STATE OF NEW HAMPSHIRE
INTER-DEPARTMENT COMMUNICATION

FROM: Grace E. Levergood, P.E. AT(OFFICE): Water Division
Dam Safety Engineer *gel* Dam Bureau

SUBJECT: Taylor River Pond Dam and Taylor River Pond Dike, Hampton Falls
Dam #106.08 (Haz. Class A to B) and Dike #106.09 (Haz. Class AA)

SITE INSPECTION FORM

Picture 3. Taylor River dam – water flowing through hole in dam alongside fish ladder entrance – November 2004.

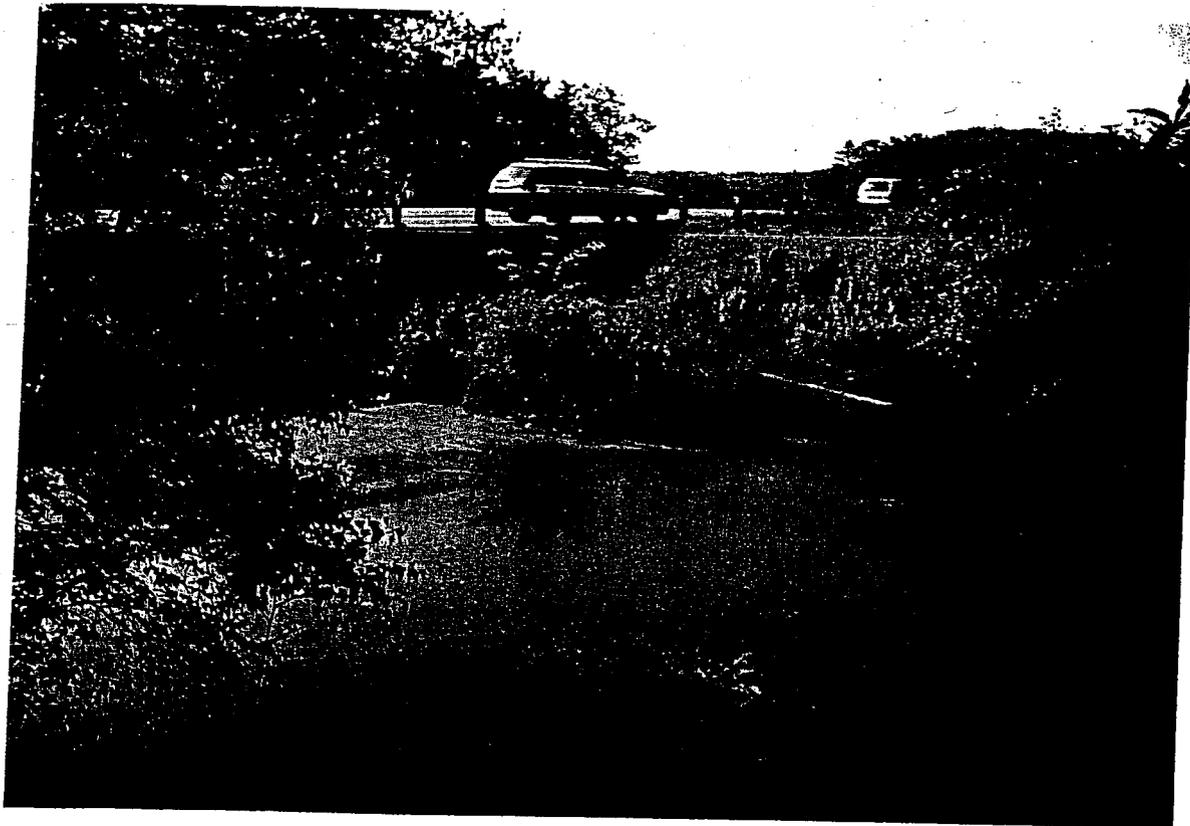
1. The sheet pile spillway was badly deteriorated with a 12" diameter hole in the downstream face adjacent to the right abutment;
2. The downstream left concrete wall of the fishway that abuts the right spillway training wall was badly deteriorated with exposed rebar and leakage;
3. Cracking was evident along the left wall of the fishway;
4. The stoplog bay sill which forms the crest of the spillway was deteriorated;
5. There was settlement of the left abutment adjacent to the sheet pile training wall;
6. There is no operation and maintenance plan (O&M) on file with the DES; and
7. An Emergency Action Plan (EAP) is now required due to the reclassification of this structure.

1. Make repairs to the steel sheet piling in the following locations:
 - a. The spillway face
 - b. The crest of the sheet pile spillway
 - c. The left abutment wall which are badly deteriorated;
2. Make concrete repairs to the fishway in the following locations:
 - a. The downstream left concrete wall of the fishway that abuts the right spillway training wall, is badly deteriorated with exposed rebar and leakage;
 - b. The left wall of the fishway that is badly cracked;
3. Bring the left earthen embankment level with the left abutment wall where there is settlement;

Picture 5. Taylor River fish ladder – deterioration at entrance of fish ladder – August 2004.

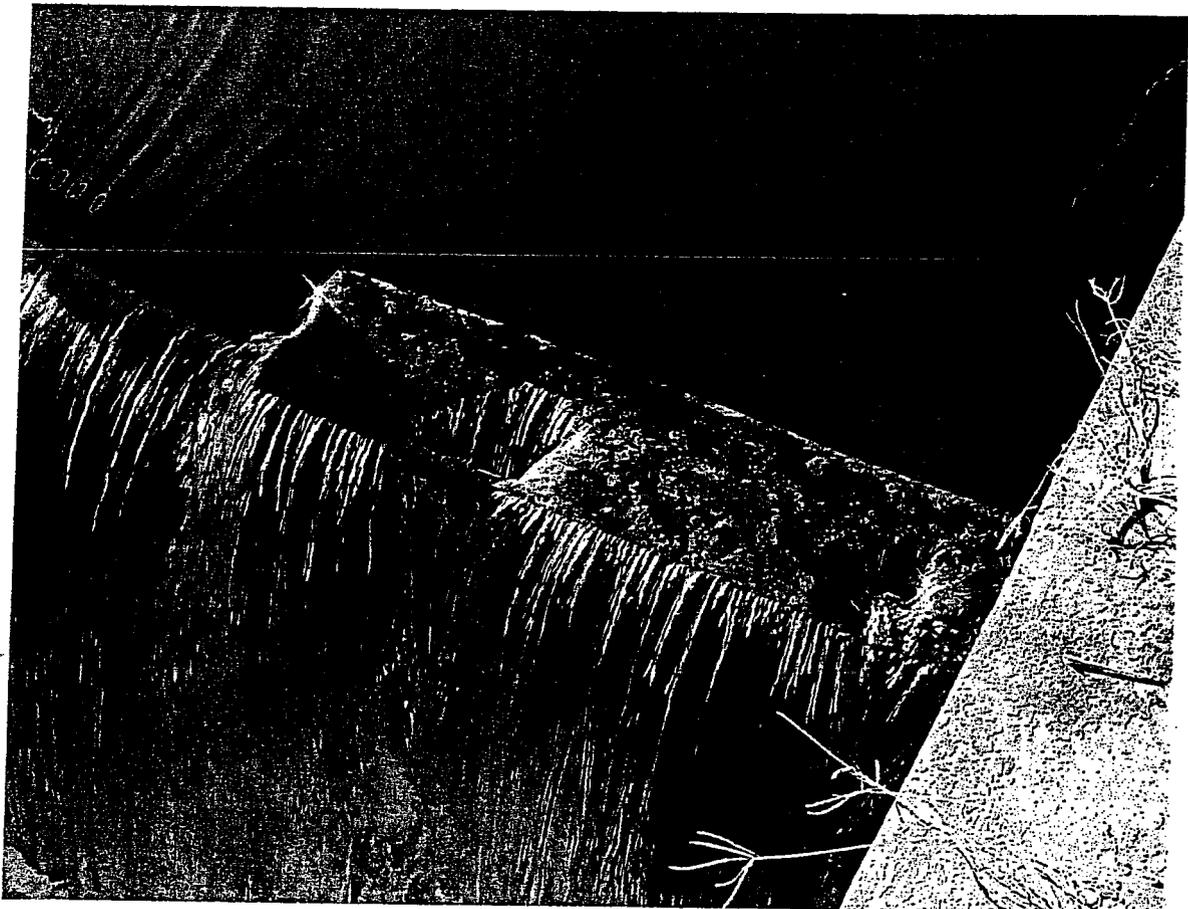
Currently, portions of the cement walls in the Taylor River fish ladder contain substantial holes that allow water to escape thereby reducing its efficiency in attracting and passing a variety of diadromous fish. The Department of Transportation (DOT) owned concrete and steel dam adjacent to I95 also is in severe disrepair that is affecting the integrity of this class A dam. A Department of Environmental Services (DES) dam inspection has been initiated and the final report will be given to DOT in late 2004. At this point New Hampshire Fish and Game, DES and DOT hope to confer on the next logical steps to be taken to remedy this situation of deteriorated structures, water quality and viable habitat for diadromous species utilizing this river system. This may be in the form of repairing the structures or dam removal.

Taylor River Dam #106.08 Hampton Falls, NH

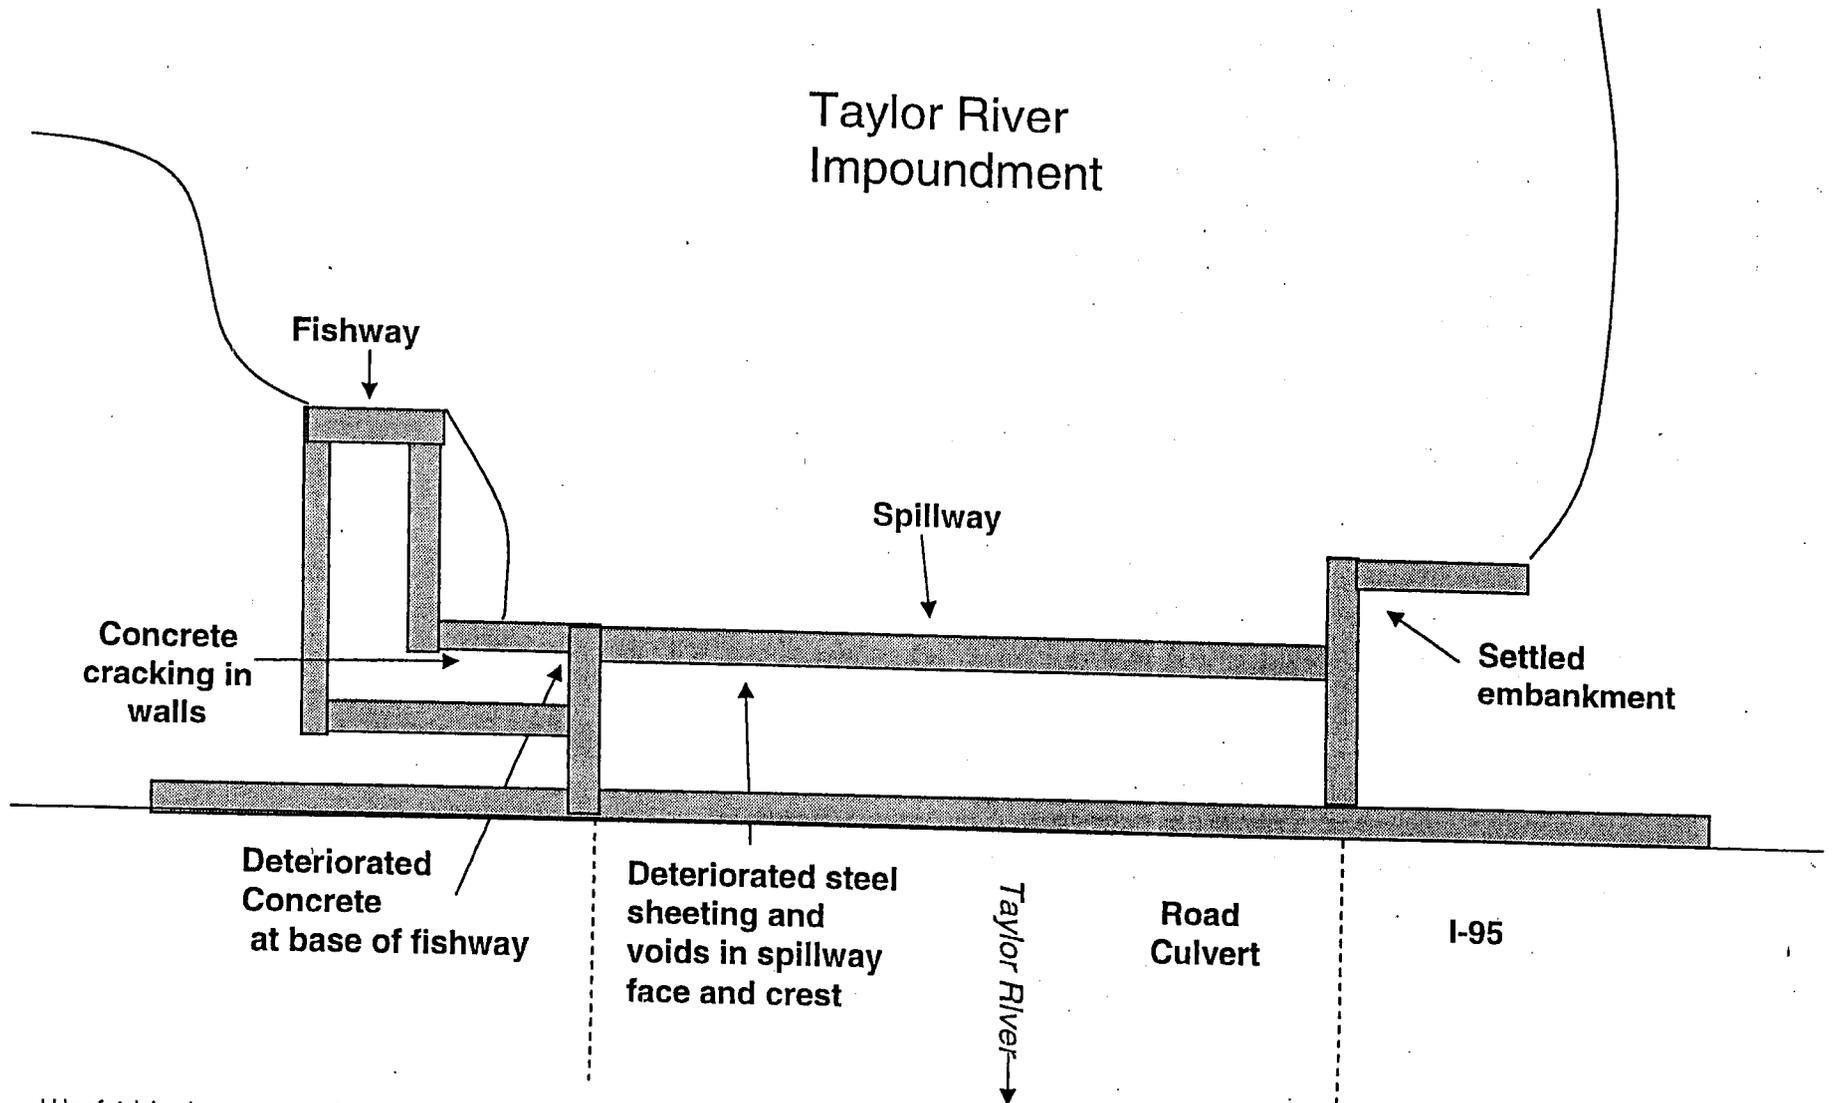
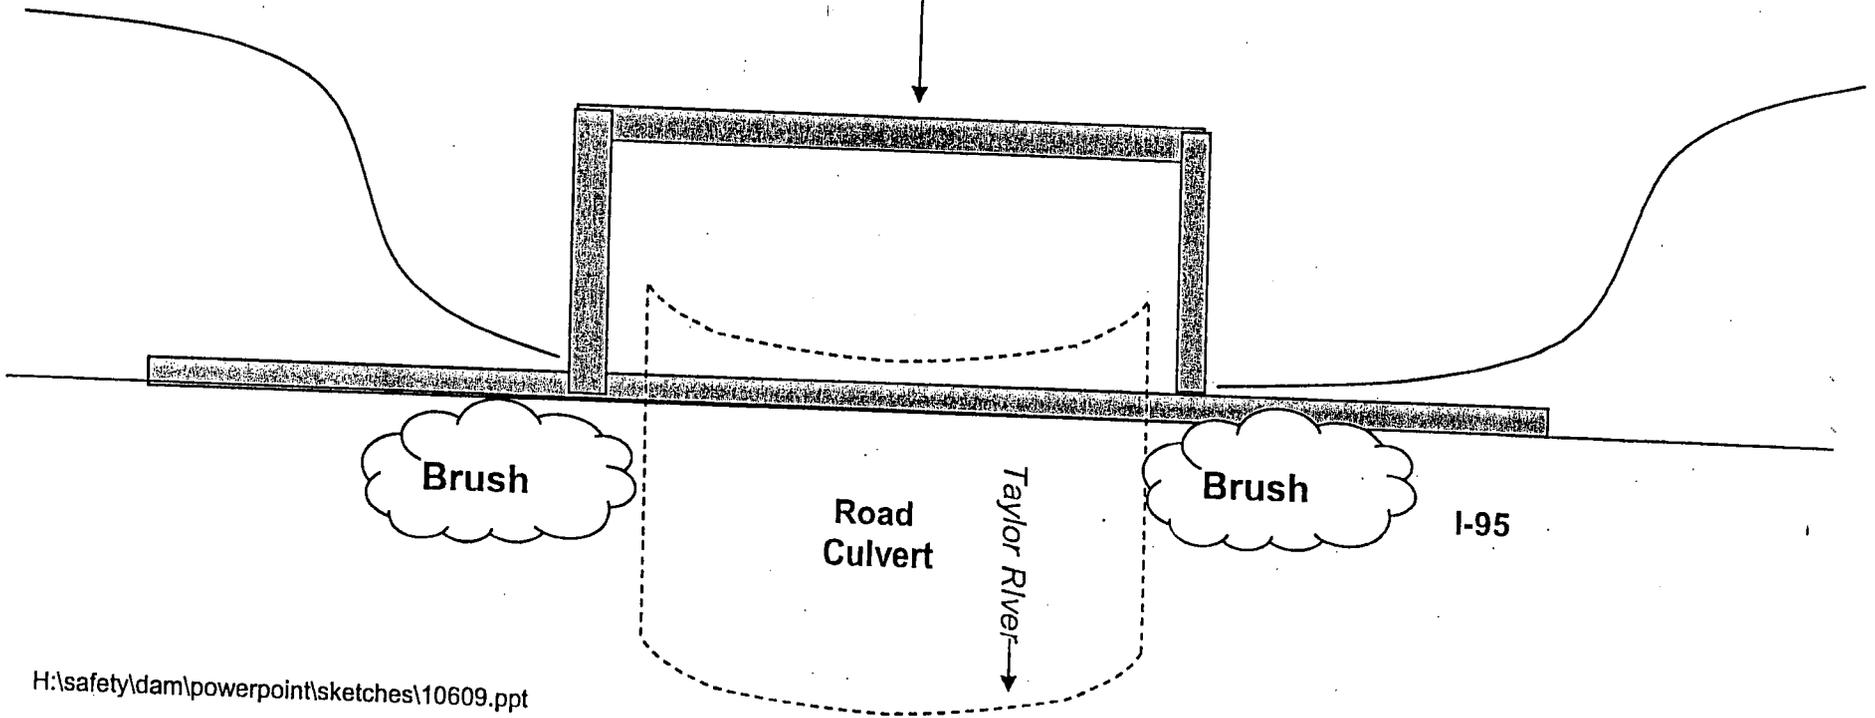
1. There was brush along the upstream face of the dam in the vicinity of the road culvert; and
2. There is no operation and maintenance plan (O&M) on file with the DES.

1. Remove the brush from the upstream face of the dam in the vicinity of the road culvert; and
2. Complete and submit to DES an O&M plan. Refer to the enclosed guidelines.
